UNITED STATES PATENT AND TRADEMARK OFFICE

APPLICATION NO.	FILING DATE	FIRST NAMED INVENTOR	ATTORNEY DOCKET NO.	CONFIRMATION NO.
10/065,772	11/18/2002	Hwang Choe	24-NS-6042	2406

Office Action Summary	Application No. 10/065,772	Applicant(s) CHOE ET AL.	
	Examiner Daniel L. Greene Jr.	Art Unit 3694

DETAILED ACTION

Fig. 2

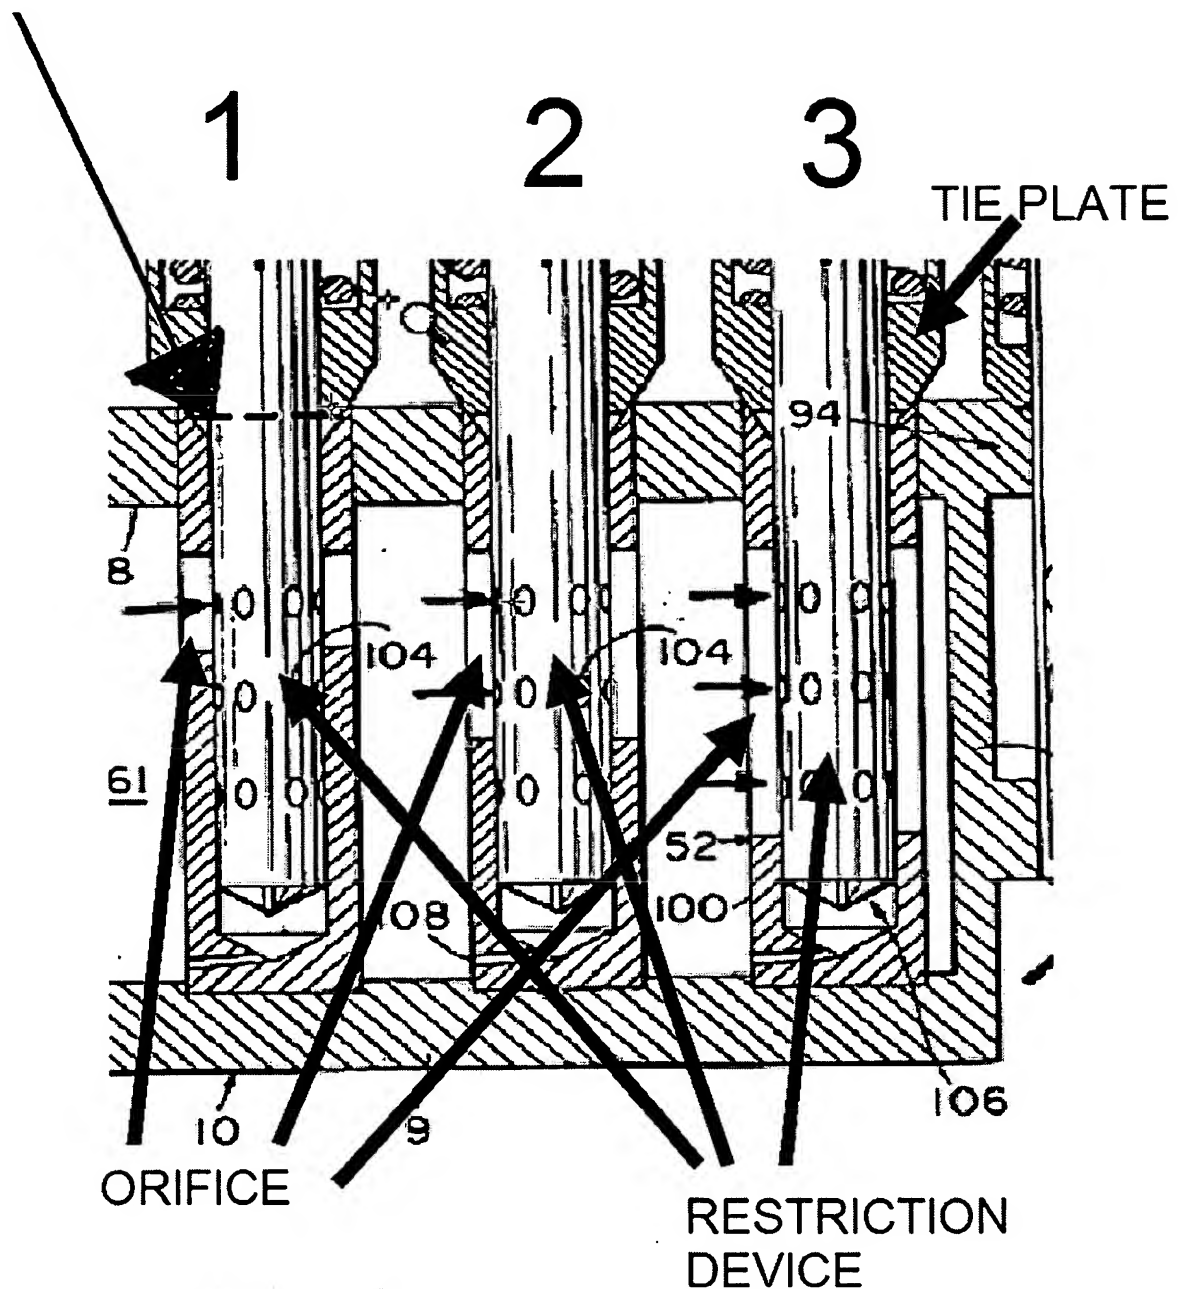
Resort will be had to Figure 2 to set forth the structural limitations

Applicant is arguing Patterson does not have.

First, the Examiner would like to point out that after further consideration it has been determined that Patterson does indeed set forth three core flow regions because as shown by Figure 2 below, the flow through EACH radial blanket fuel assembly the examiner has labeled as 1, 2 and 3 will indeed be different due to the different size of the orifice that lets water into each said fuel assembly.

Second, as clearly indicated by the Examiner, each radial blanket fuel assembly does indeed have its own restriction device that is indeed detachably coupled to the lower end of the lower tie plate as the limitation "detachably coupled" is encompassed by using a cutting torch to detach said restriction devices from the lower tie plate as evidenced by the words "cut along dotted line to detach restriction device"

CUT ALONG DOTTED LINE TO DETACH
RESTRICTION DEVICE

Indeed, it appears some of the issues with determining exactly what Applicant is attempting to claim is due to the failure of the drawings to show exactly what applicant's invention is. However the limitation "detachably coupled" is really an intended use or how the applicant would like the restriction device to be attached. There is nothing that would prevent anyone from cutting off the restriction devices of Patterson, that is to make them detachably attached.

Yasuyaki was cited to show flow through three regions of the core was obvious to do and as such was simply redundant because, as set forth above, Patterson does indeed set forth three different flow rates controlled by orifices of three different sizes.
